Re: FortisBC Energy Inc. (FEI)

Application for a Certificate of Public Convenience and Necessity for the Okanagan Capacity Upgrade Project (Application)

Response to the Commercial Energy Consumers Association of British Columbia (CEC) Information Request (IR) No. 1

Figure 5-4: Proposed Resources and Organizational Chart

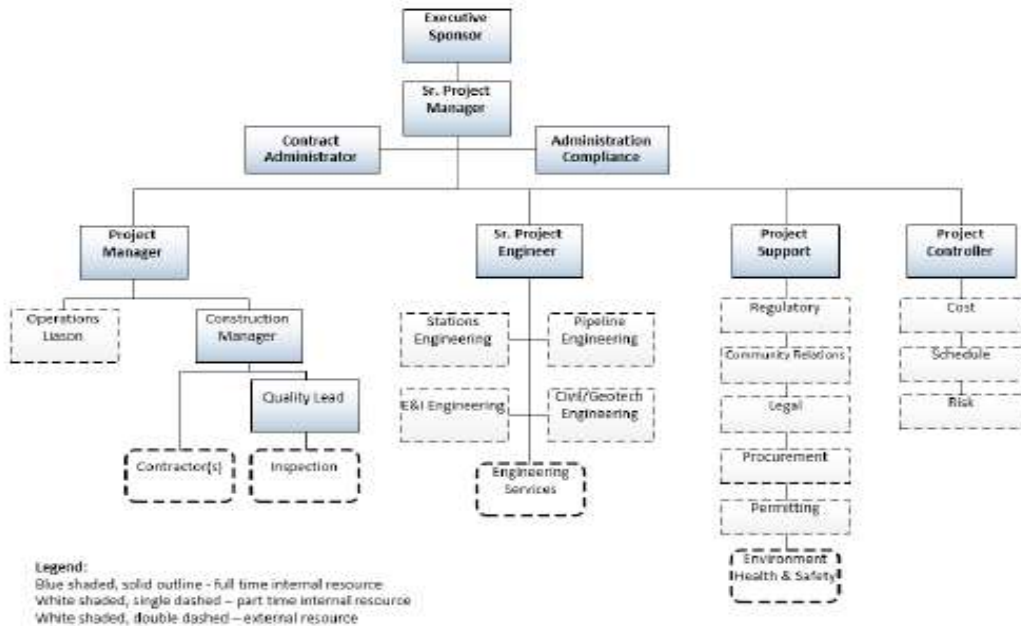
1 **29. Reference: Exhibit B-1-2, page 80**

9 Confirmed, the Contractor, Inspection, Engineering Services and Environment Health and
 10 Safety positions identified in Figure 5-4 above are external resources.
